## PIC18F2515/2610/4515/4610 Rev. A3 Silicon Errata

**The following silicon errata apply only to PIC18F2515/2610/4515/4610 devices with these Device/Revision IDs:**

**FIGURE 1: SCK PULSE VARIATION USING TIMER2/2**

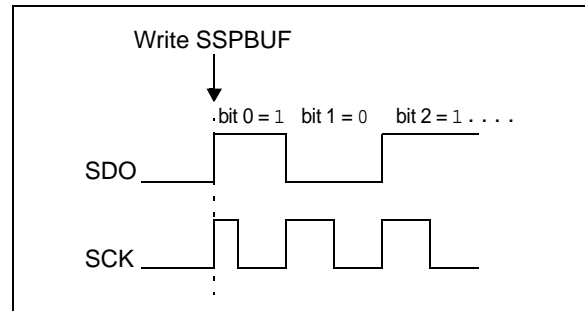
When the SPI is using Timer2/2 as the clock source, a shorter than expected SCK pulse may occur on the first bit of the transmitted/received data (Figure 1).

To avoid producing the short pulse, turn off Timer2 and clear the TMR2 register, load the SSPBUF with the data to transmit and then turn Timer2 back on. Refer to Example 6 for sample code.
